Floyd Hill Design - Technical Team Meeting Summary

October 28, 2022, 9 AM to 12:00 PM

CDOT Golden Office – Lookout Mountain Conference Room and Virtual (Zoom)

I-70 Floyd Hill to Veterans Memorial Tunnel
Noise Wall - Proposed Conditions

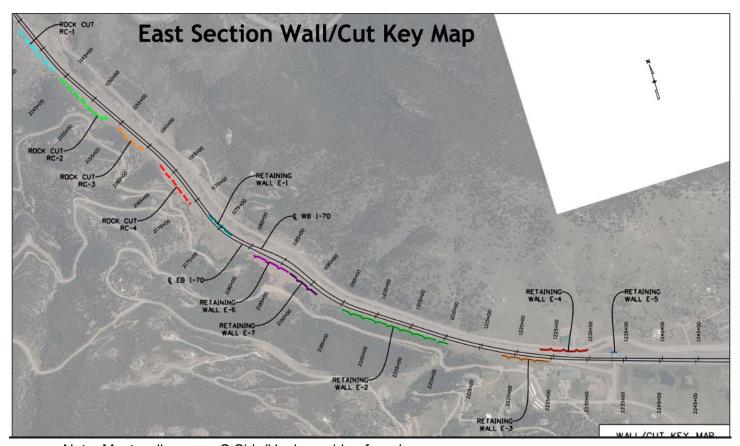
- **TT Comment:** There are similar sound walls along C-470 and they have created shading along the multimodal path, which leads to ice on the trail. This will depend somewhat on how far away the wall is from the trail, but that is a concern.

- TT Comment: Idaho Springs is excited about this wall for the benefits to community members. However, there are some concerns for safety as this wall blocks a section of the road from the creek which could impact emergency response access.

- **TT Question:** Are there other options to these plain panels? Other structure types?
- **Project Team Response:** This rendering is certainly not a final design, just a first look at the location of the wall. In terms of materials, the tradeoff becomes cost and weight.

- **TT Comment:** There are examples of sound walls that blend better with mountain landscapes, incorporating variable heights and an irregular edge for example.

• **TT Comment:** This image as shown does not blend well with the surroundings, even making it a similar tan color to the bridge structure would make it look better.

- TT Response: This is an important consideration, although Idaho Springs will
 maintain the adjacent trail which should reduce icy spots.
- Project Team Comment: The height of the wall is based on sound models and the position/location in relation to the highway and the trail is based on the location of underground utilities, aiming to reduce disturbance.

- **Project Team Response:** It would be helpful if you want to send us pictures of examples of sound walls you like. This rendering depicts a wall of 16 ft, however the model required a wall from 14-16 ft which allows for some variation in height.
